# **REPORT ON WESTERN ROAD**

## REPORT ON WESTERN ROAD – TREE PROPOSALS

## Western Road

## **Outside No. 92: SA. Recommend Replacement**

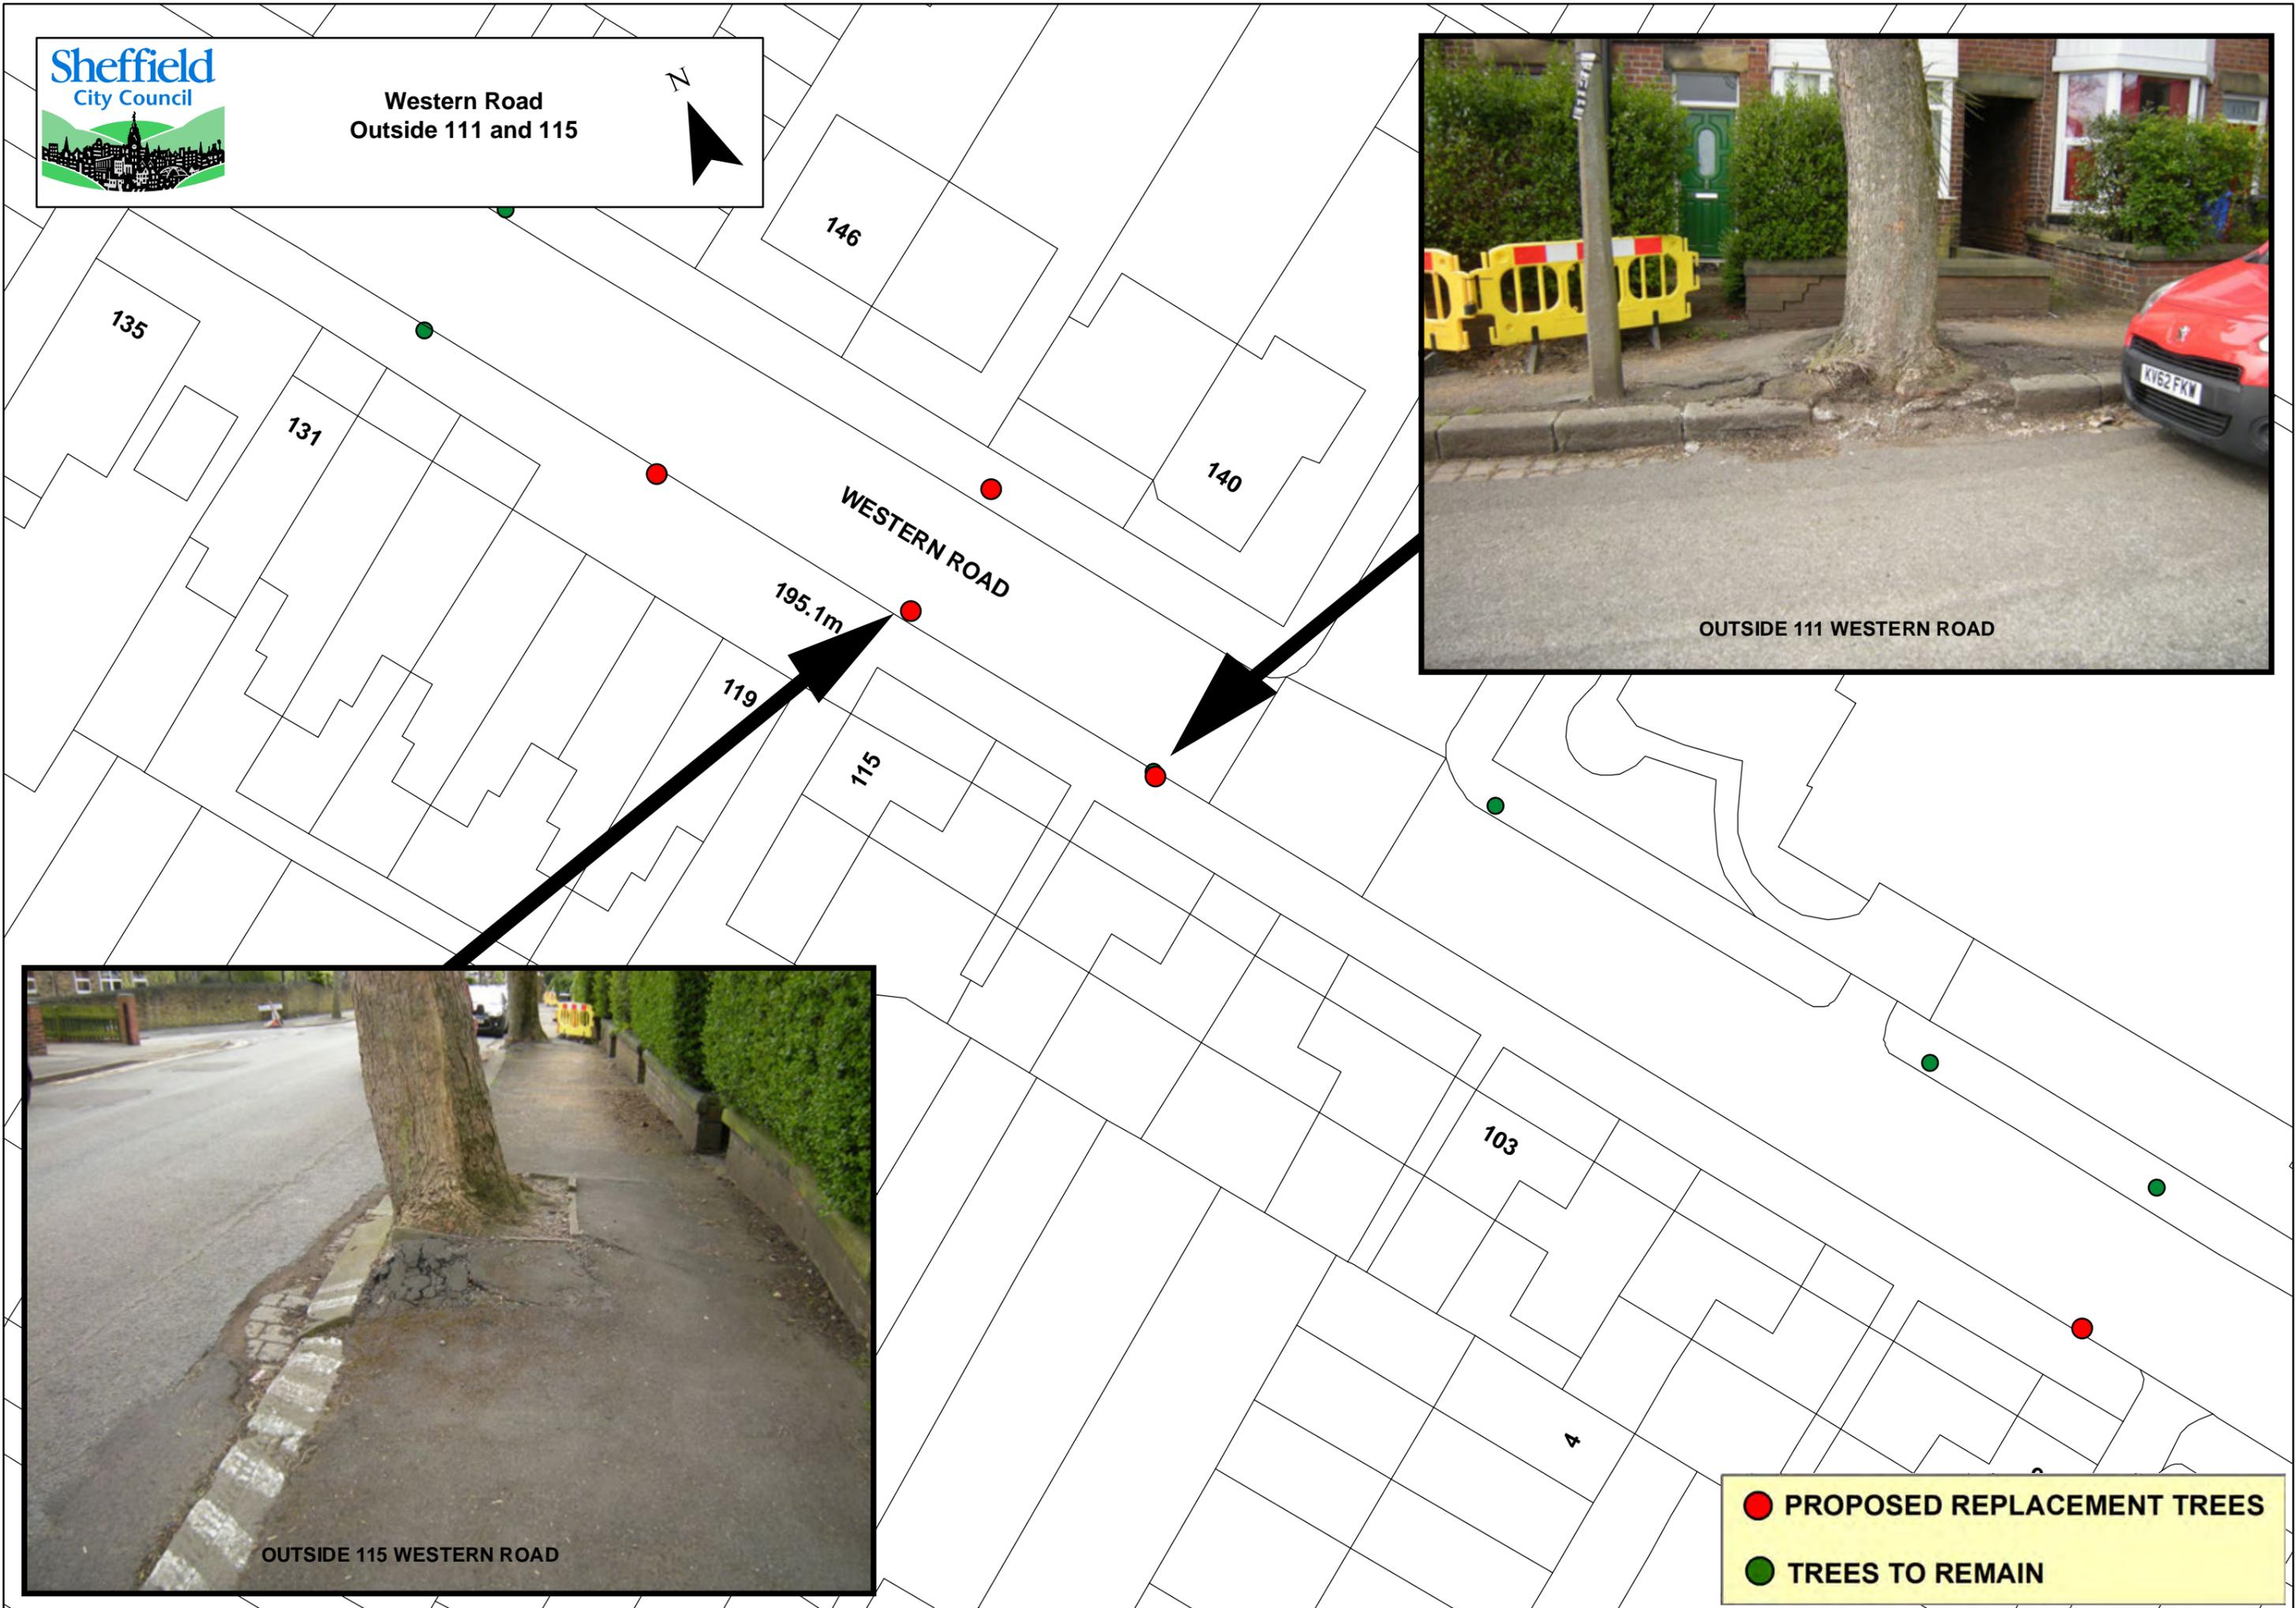
**Evidence of slight bowing to wall: Cannot install full kerb at this location as it would encroach channel line. Kerb already missing due to be pushed out by roots. Roots would therefore prevent half kerb suggested by ITP**

## **Outside No. 142: Recommend Replacement:**

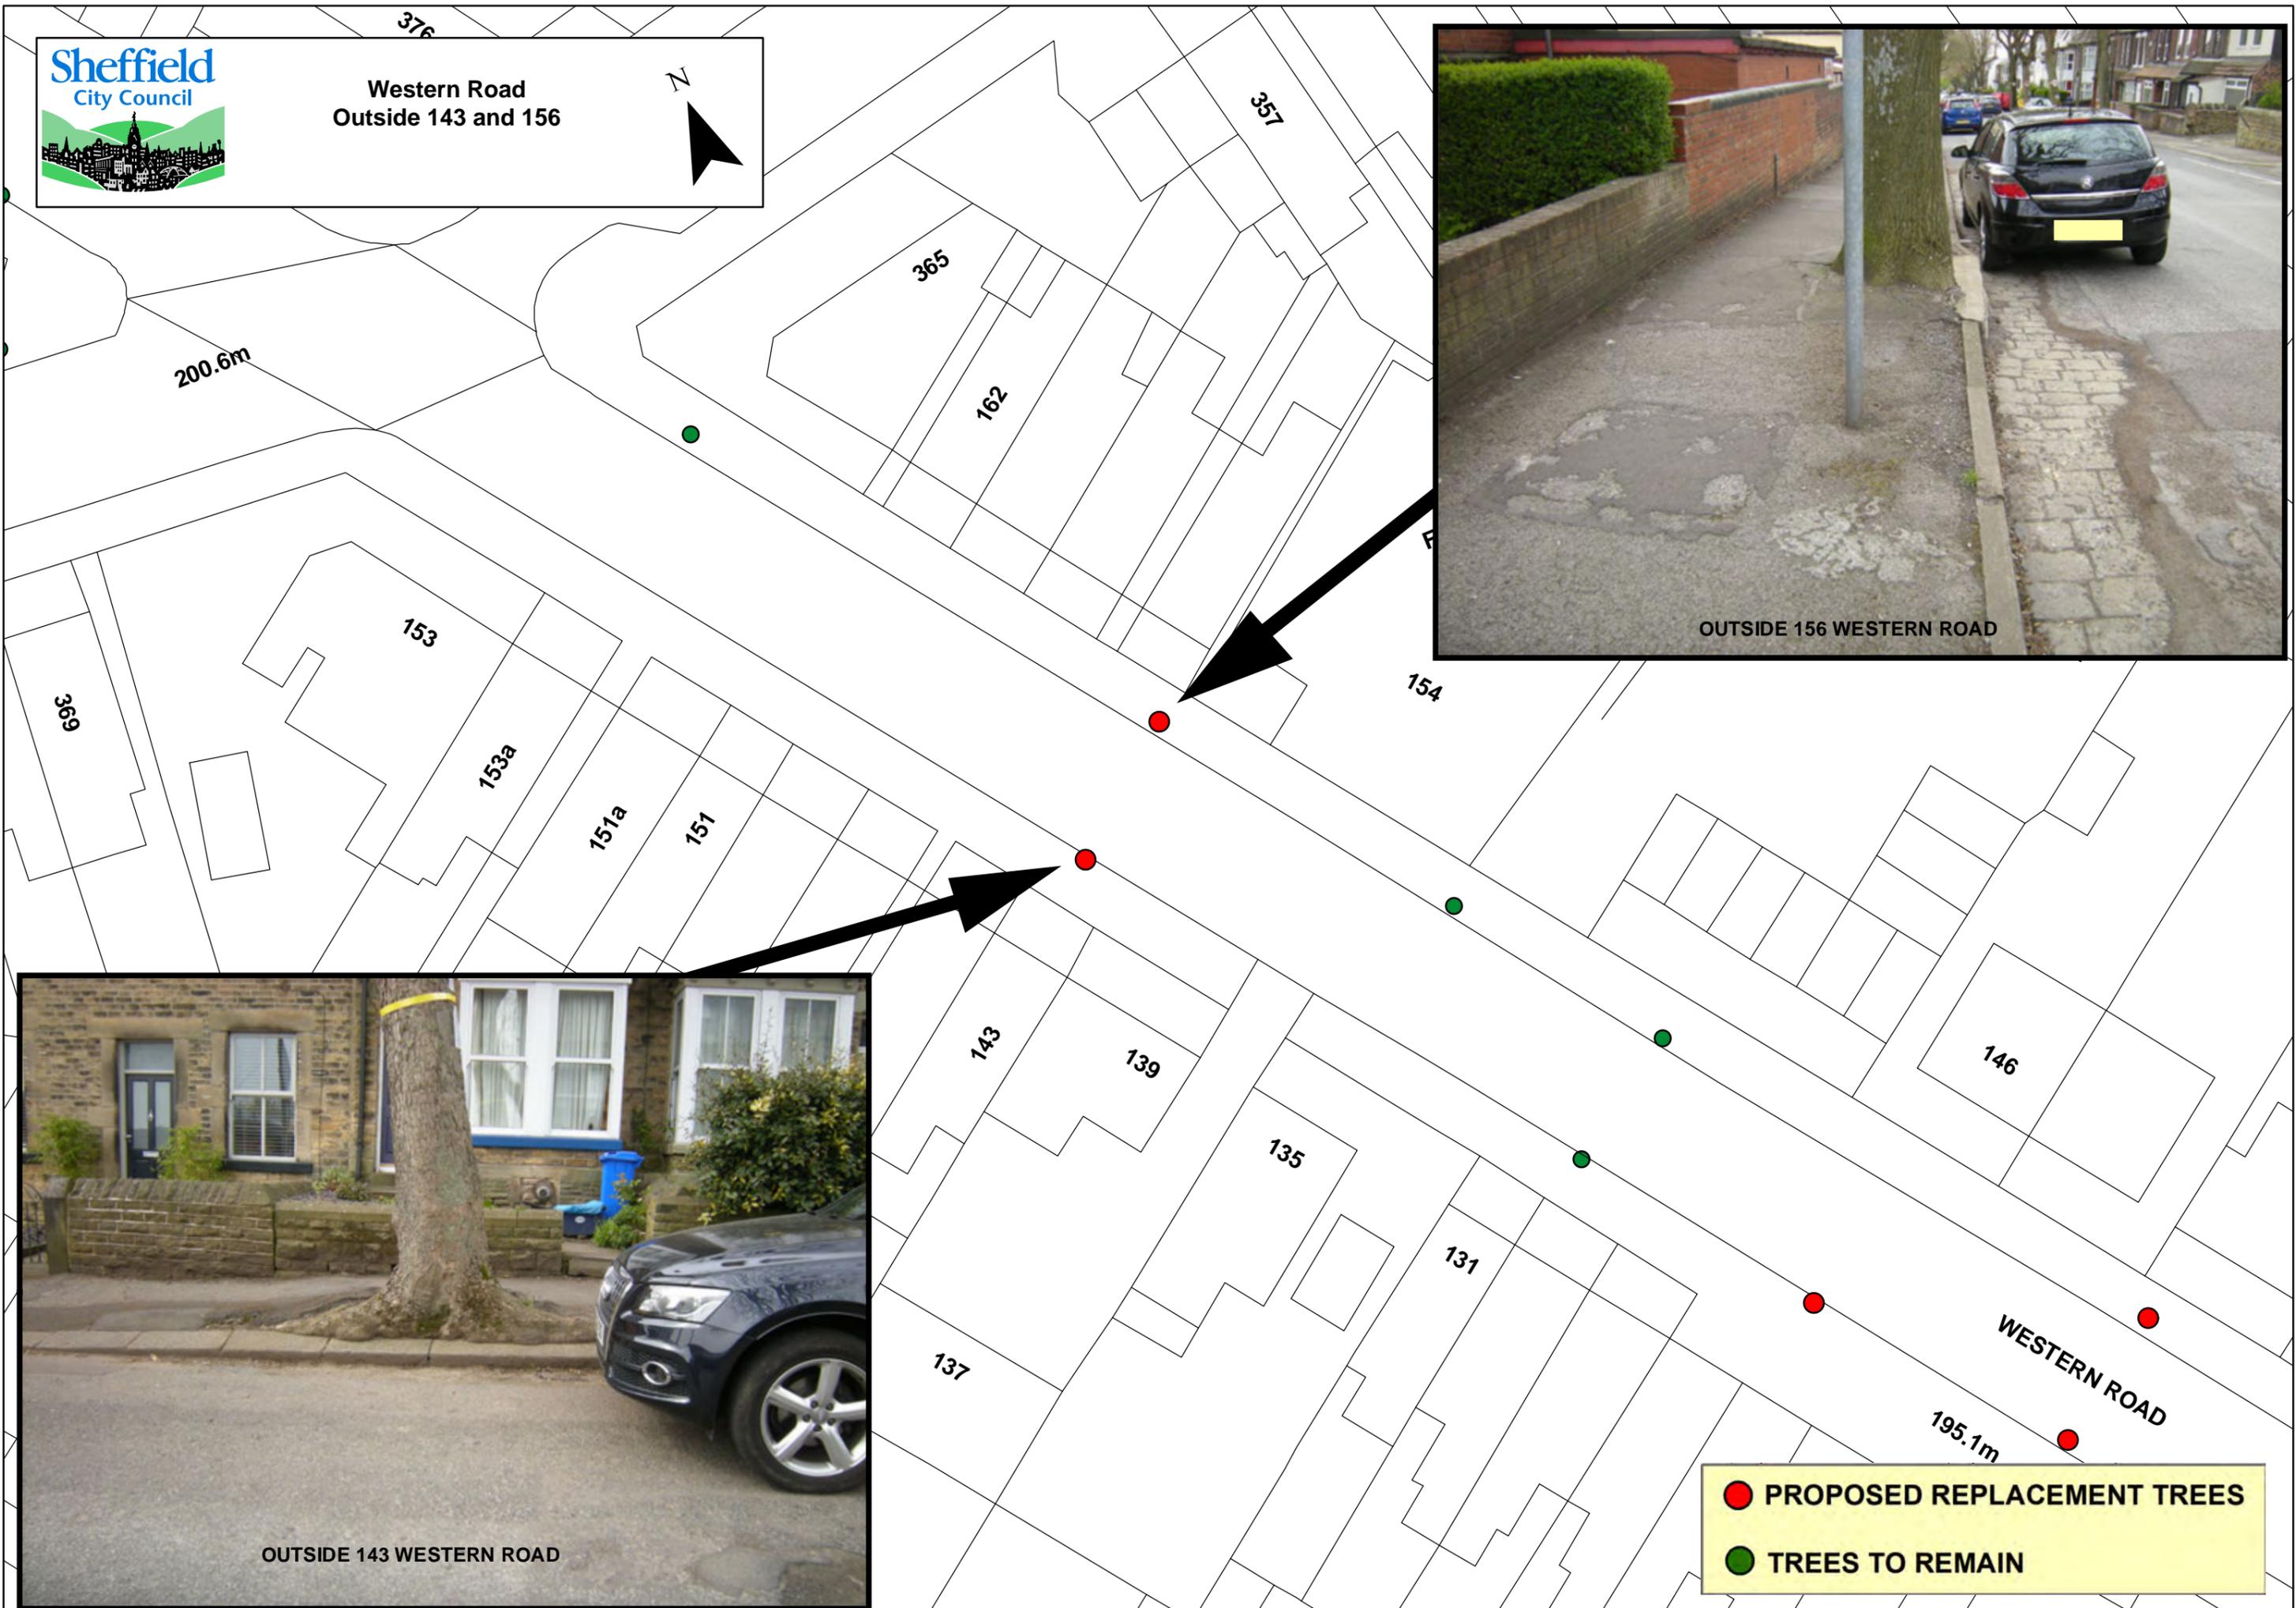
**Kerb displaced. Unable to reset half kerb as roots in carriageway line of channel as suggested by ITP . Also evidence of roots tracing to third party wall with slight distortion occurring to wall near access point which is partially being obstructed. Further ramping would cause severe backfall into property on the narrowed section of footway.**

**Outside No. 209: Recommend Replacement: ITP & Airspade in Agreement:**

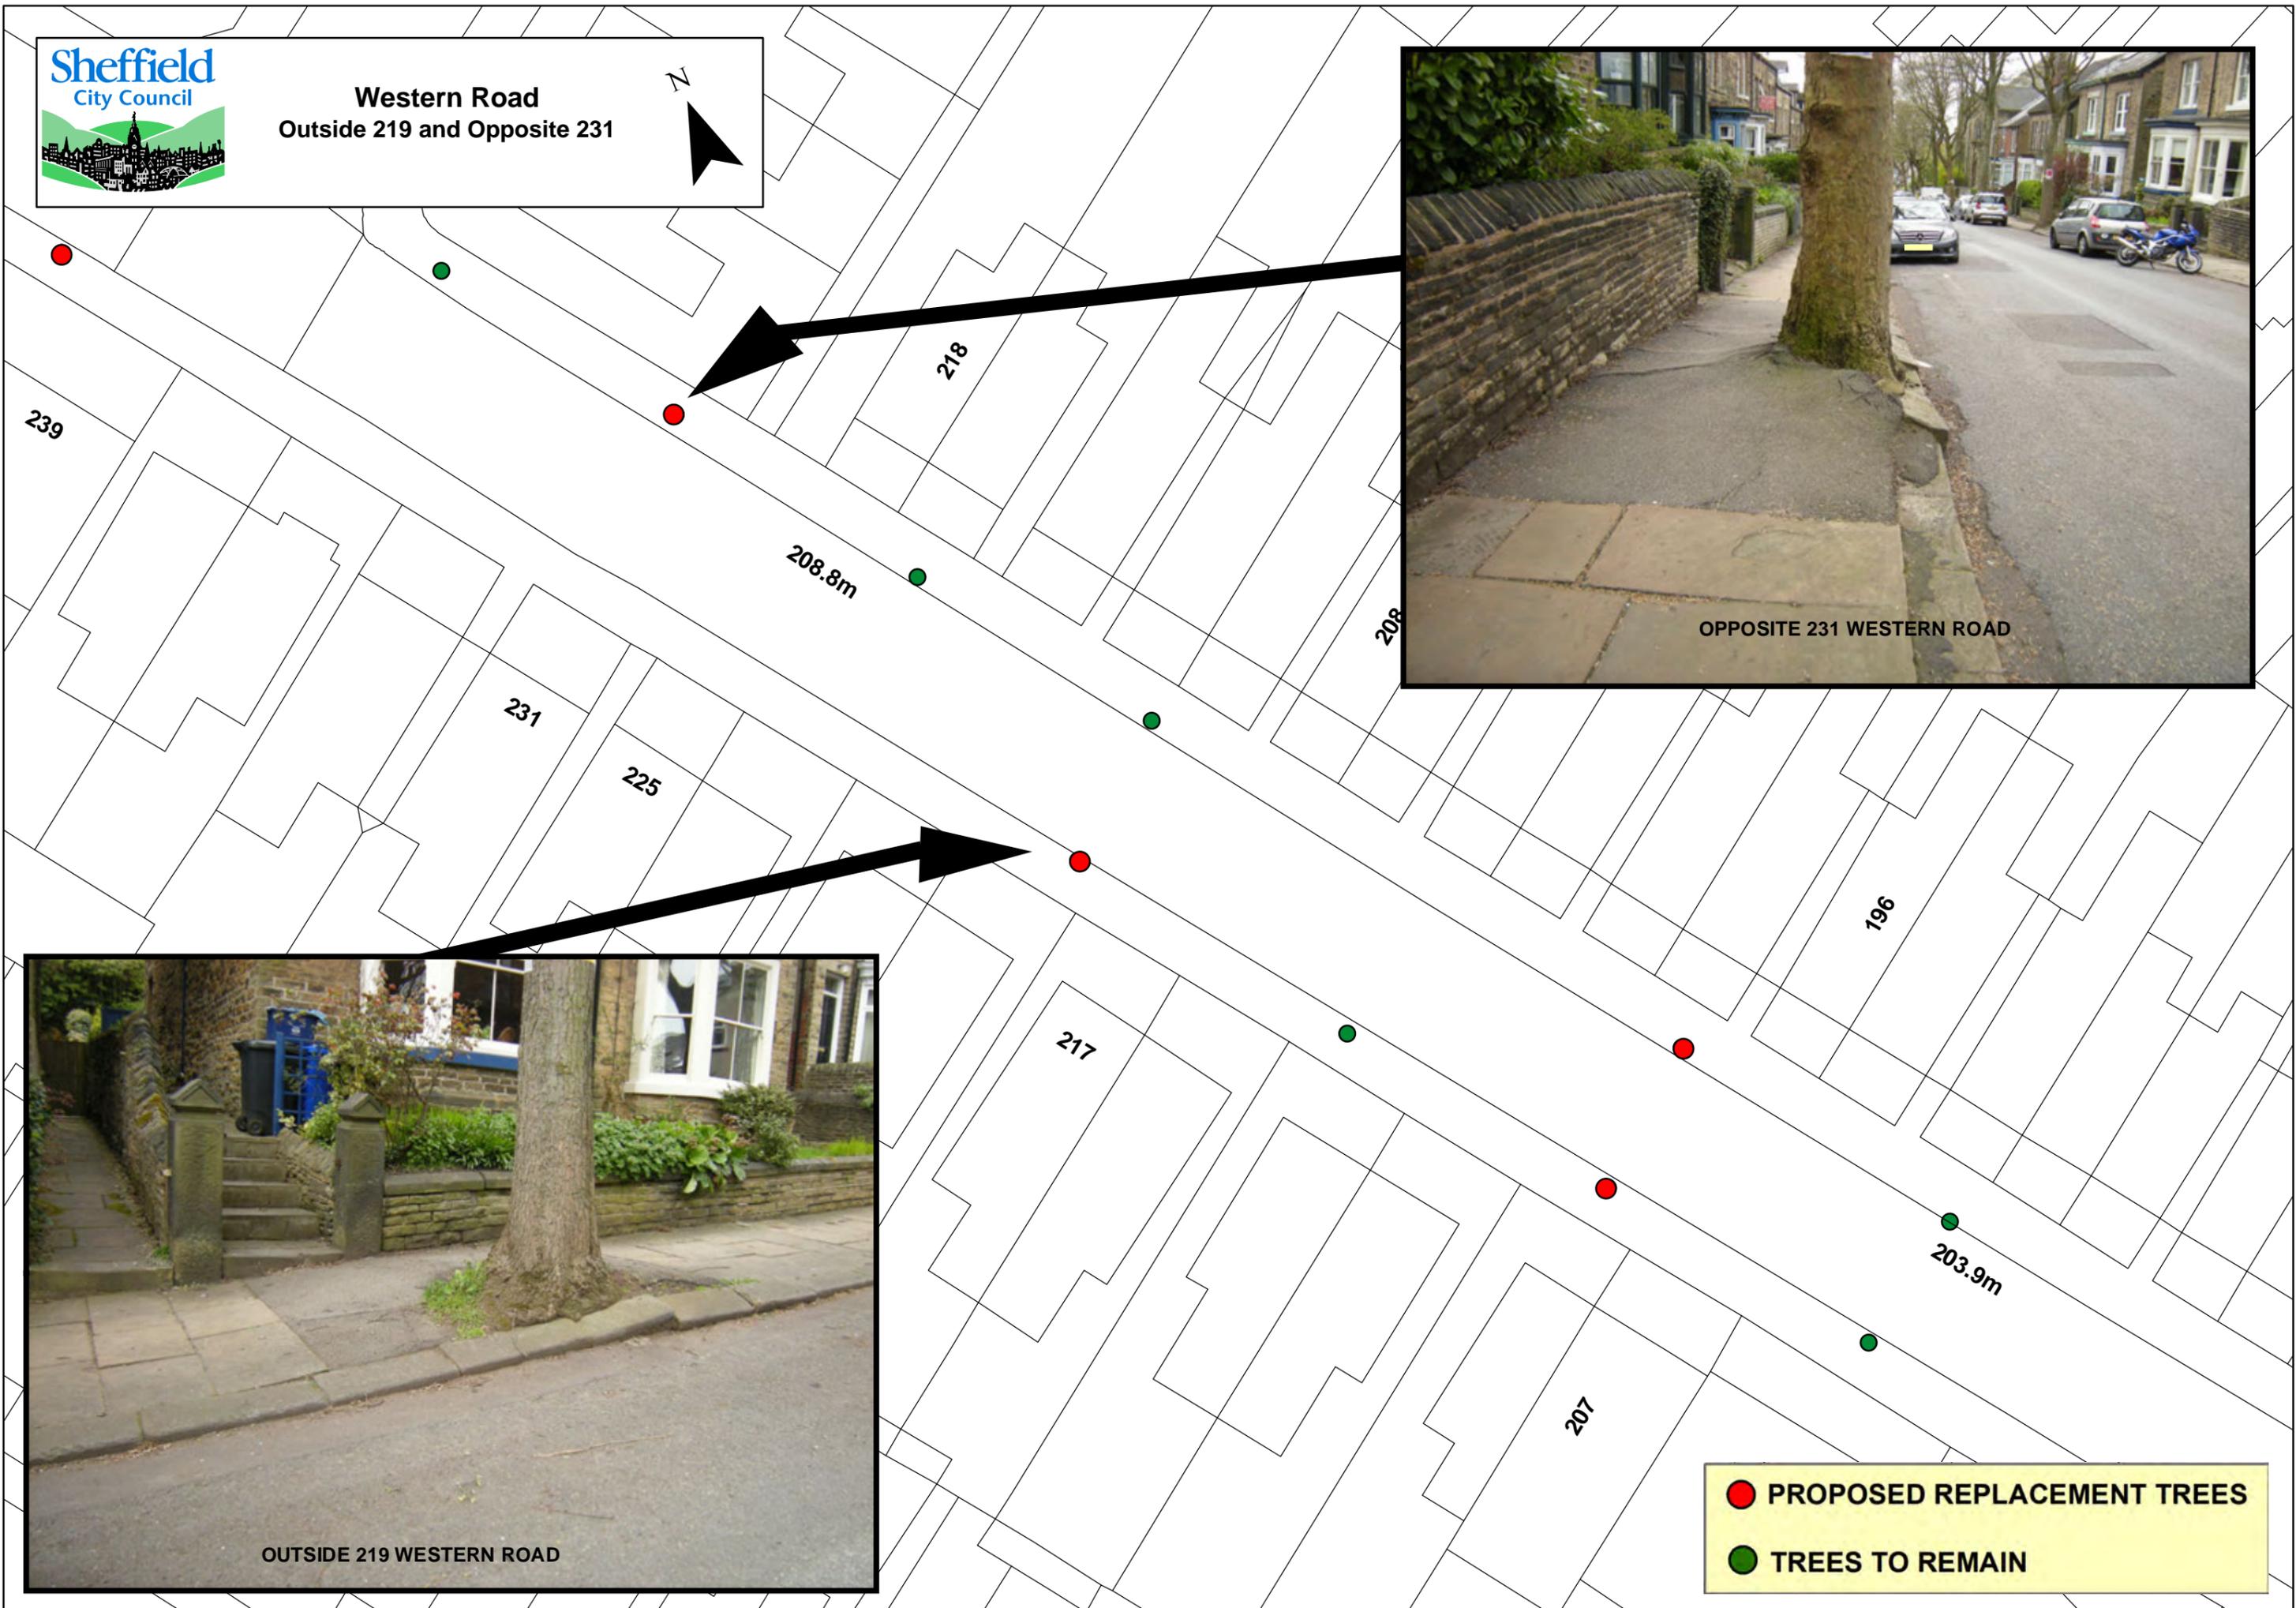
**Roots displaced kerbs beyond existing channel line. Severe root damage to footway and potential 3<sup>rd</sup> party wall damage. Tree felling and replacement - kerbs displaced by buttress. Footway ramped by shallow roots - Verified third party damage**

**Roots growing into 3<sup>rd</sup> party property causing damage. Continue with replacement.**
